Noise Impact Assessment Proposed Manufactured Housing Estate 34 Wyndella Road, Lochinvar, NSW

Response to Council RFI – October 2024

Subject: Response to Council RFI: 34 Wyndella Road, Lochinvar

Figure 1 – Aerial view of project site (source: Google Earth)

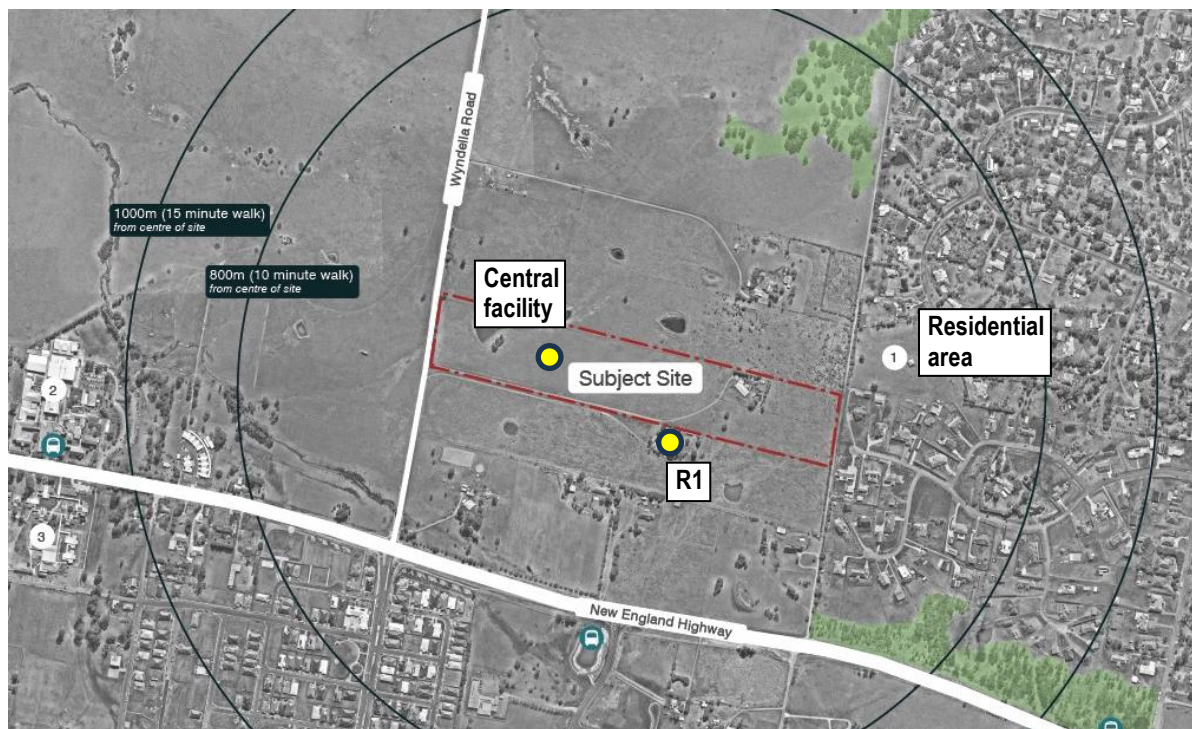
They only have 1 x sensitive receiver called R1 which is 350m away from the site.

Noise from the proposed central facilities requires assessment and R1 is the closest existing receiver by a considerable margin. Compliance at the most impacted receiver implies compliance at all more distant receivers.

Figure 2 – Potential location for music and external recreation sources

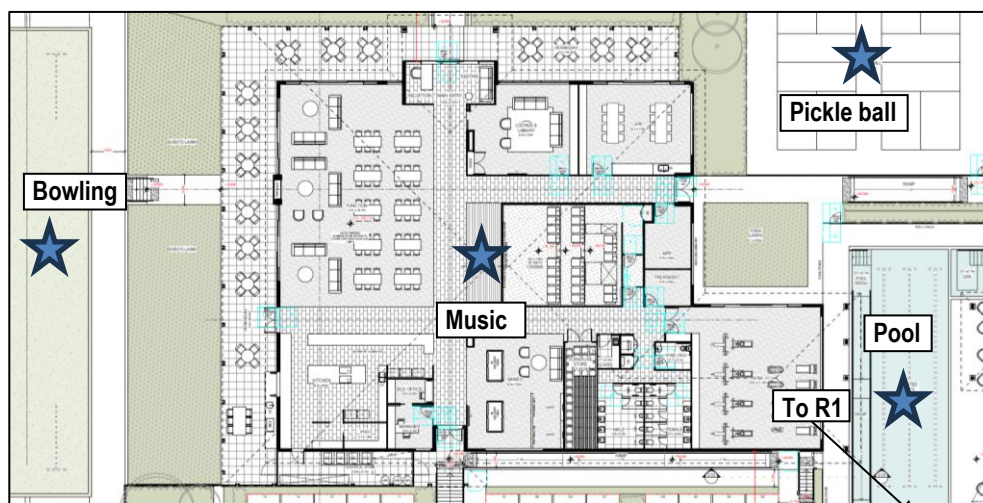
The assessment shows that they have adopted a background level of 30bBA with a criterion of 35 that should not be exceeded. Whilst it could be assumed that this loss may occur to the nearest sensitive receiver, the assessment does not include assessment of outdoor areas, the pool and the pickleball courts. They will all be in operation and will contribute to noise from the property that is likely to affect the nearest sensitive receiver. These areas will likely be used up until about 9pm, particularly during daylight savings time. This needs to be added to the assessment for cumulative noise from the proposed development.

The noise assessment allows 20 patrons with 10 people speaking in the outdoor area. This is assumed to be on 2 sides of the recreational facility. It is Council's opinion that this calculation should be doubled at least, given that 194 residents (assuming 1 person per unit) are to be occupying the site. From Council's experience residents flock to these locations at about 4pm and don't leave until about 9pm. It is suggested that this impact will be a lot higher, and this noise will travel towards the highway and maybe towards Pennparc.

The outdoor areas including pool, pickleball courts and bowling greens are closest to R1 and at greater distance from Pennparc Drive residences. The cumulative predicted noise level of <10 dB at R1 in our acoustic assessment will be lower at Pennparc Drive. These are imperceptible noise levels at all off-site receivers.

Considering 100 people speaking rather than 10 as adopted in our assessment, the sound power level of patrons would increase by 10 dB relative to the 80 dB(A) adopted in our assessment. Our assessment was incomplete as a propagation calculation for this source was not conducted. In completing that calculation using the same methodology as presented in Table 4 of our report, excluding internal losses and breakout from the building, the predicted level of 10 dB(A) at R1 remains well below the noise trigger level.
